(III) ACTION AGENDA

(1) SP2025-032 (HENRY LEE)

CASE NUMBER: SP2025-032; Site Plan for 855 Whitmore Drive

APPLICANT: Dub Douphrate; Douphrate and Associates **CASE NUMBER:** SP2025-033; Site Plan for Timpa Law Office

RIGHT ELEVATION

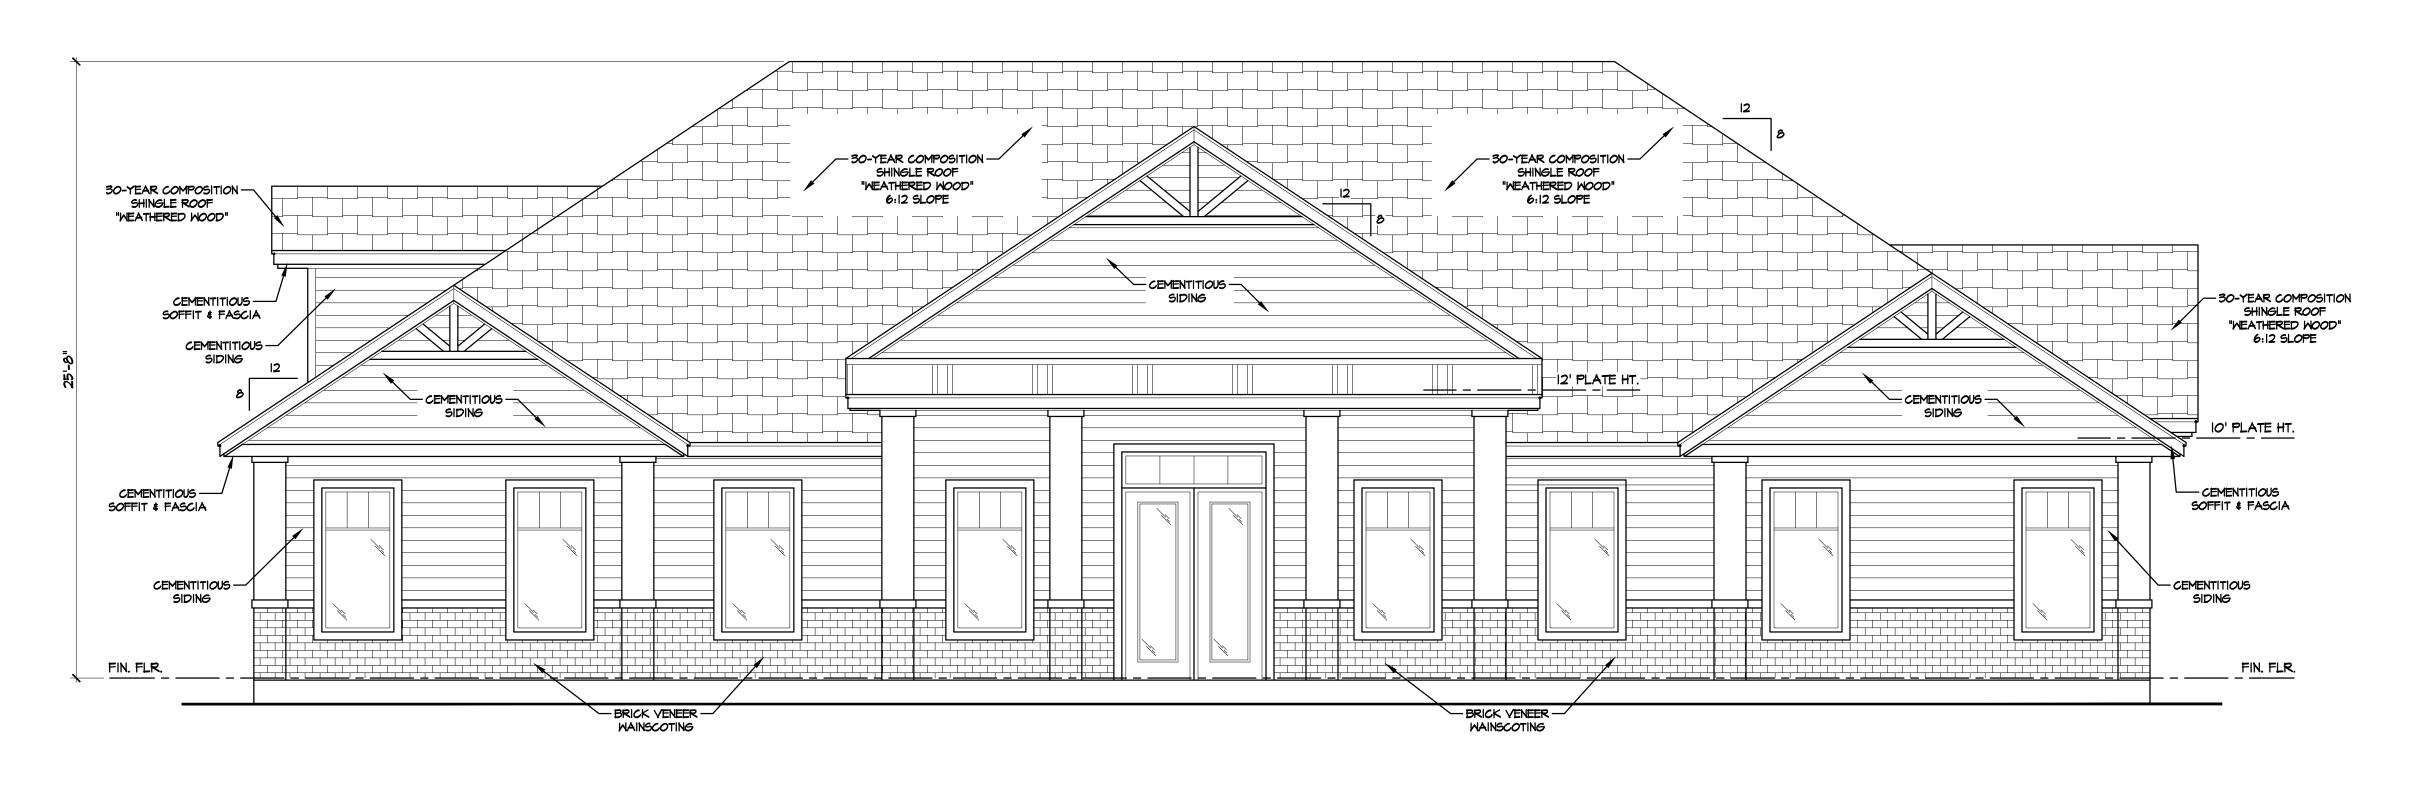
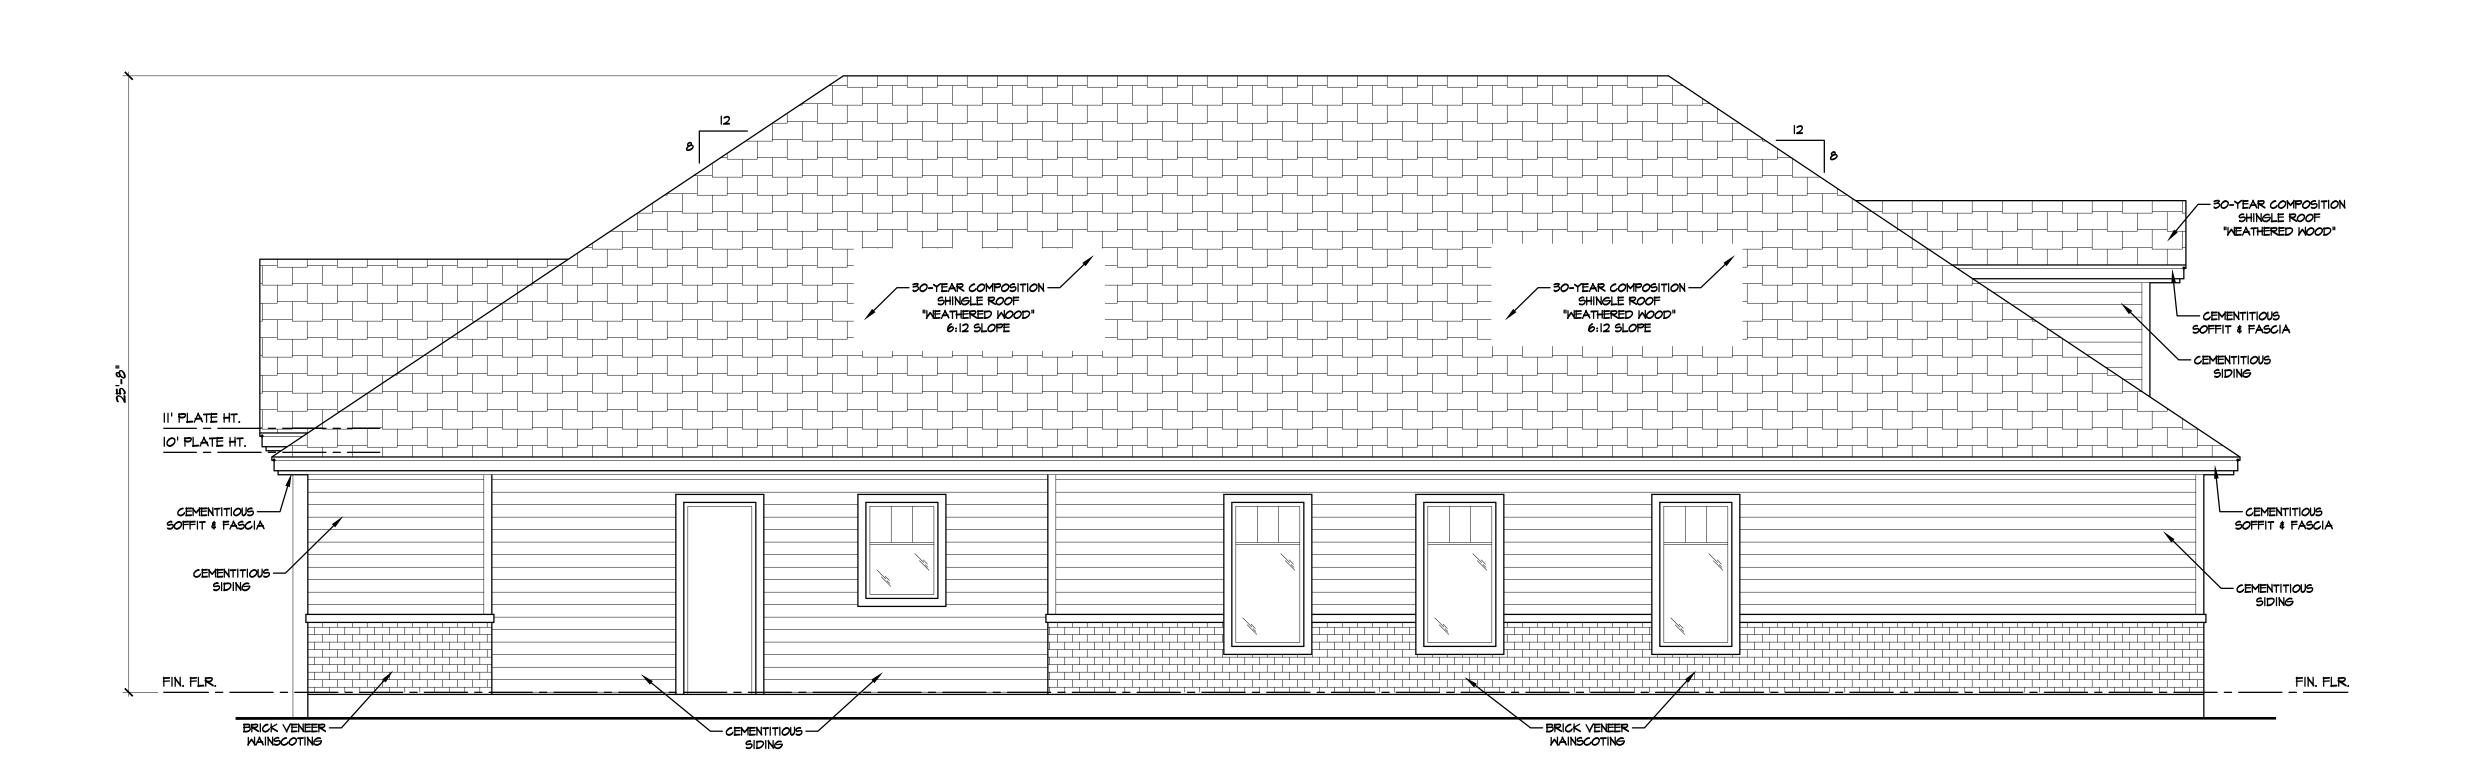
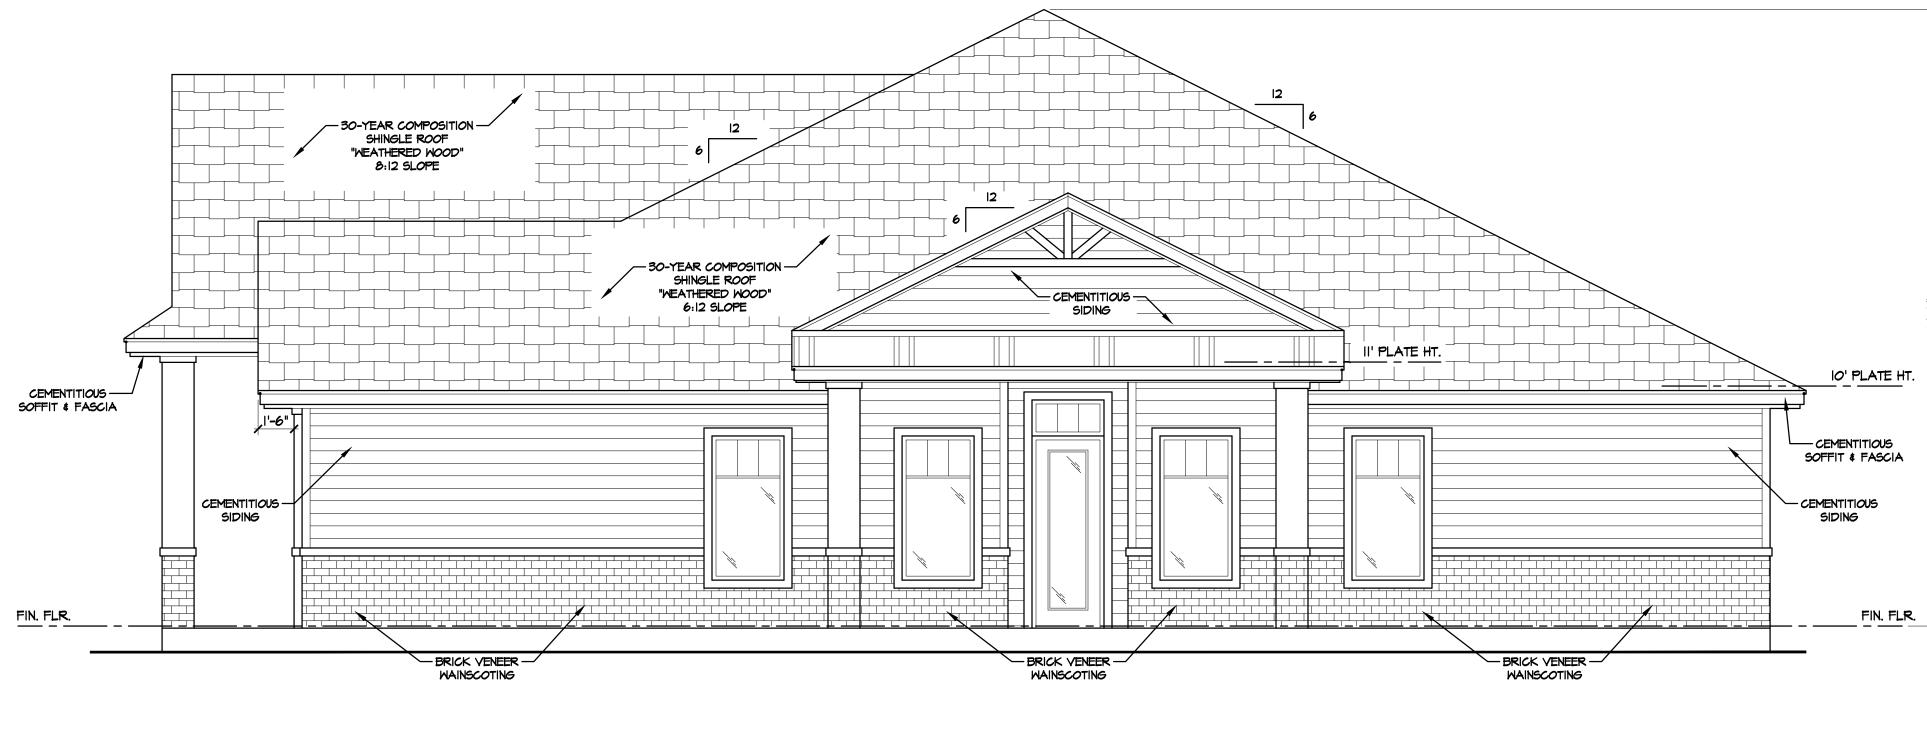
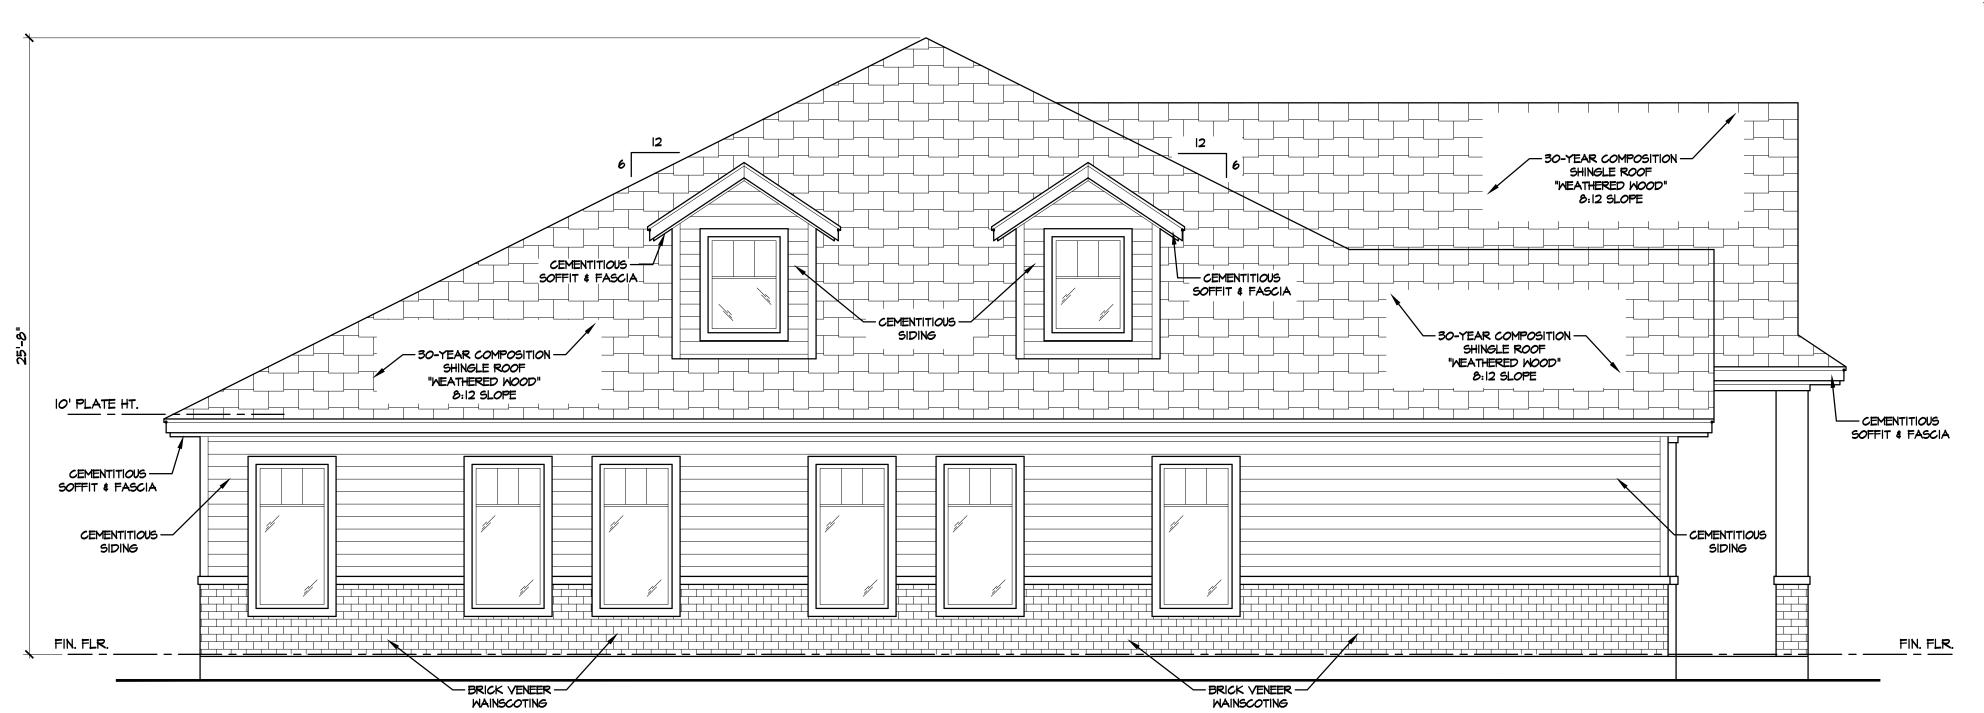
(1) <u>Building Articulation</u>. According to Subsection 04.01 (C)(4), <u>General Commercial District Standards</u>, of Article 05, <u>District Development Standards</u>, of the Unified Development Code (UDC), a secondary building façade wall length "shall not exceed three (3) times the wall height." In this case, the rear and left building elevation exceeds this requirement. This will require an <u>exception</u> from the Planning and Zoning Commission pending a recommendation from the Architectural Review Board (ARB).

The Architectural Review Board (ARB) reviewed the building elevations provided by the applicant on August 26, 2025, and requested that the applicant double front the building so that it appears to have entrances on to S. Goliad Street and Bourne Street. The applicant has made the requested changes and prior to action being taken on this case the Architectural Review Board will review the building elevations and provide a recommendation to the Planning and Zoning Commission for the <u>September 30, 2025</u> meeting.
